Access Compliance Report

Intersection ID: 29709	Main Street: COLE_MILL_RD	Cross Street: LUTHERS_ROCK_CT	Location: E
ADA ID: E2AEC3C6DA64	Ramp Type: BlendTrans1	Initial Pass/Fail: Fail	Overall Compliance: No
		Severity Score: 8.75

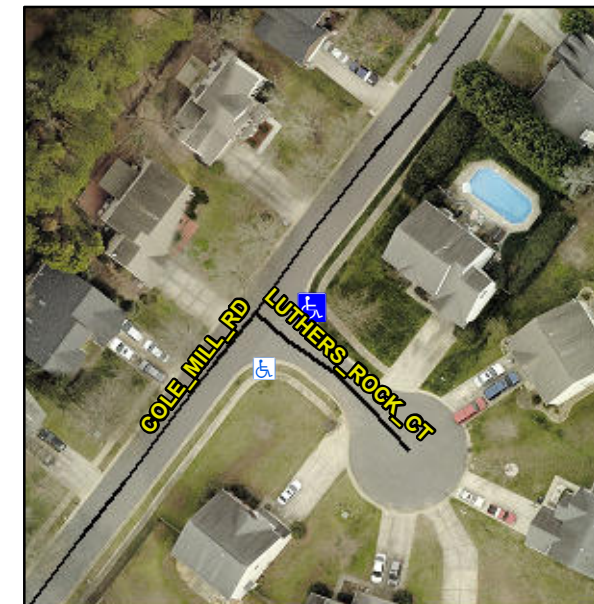
Remove & Replace Curb Ramp With Two New Directional Ramps or Equivalent.

R304.5.1
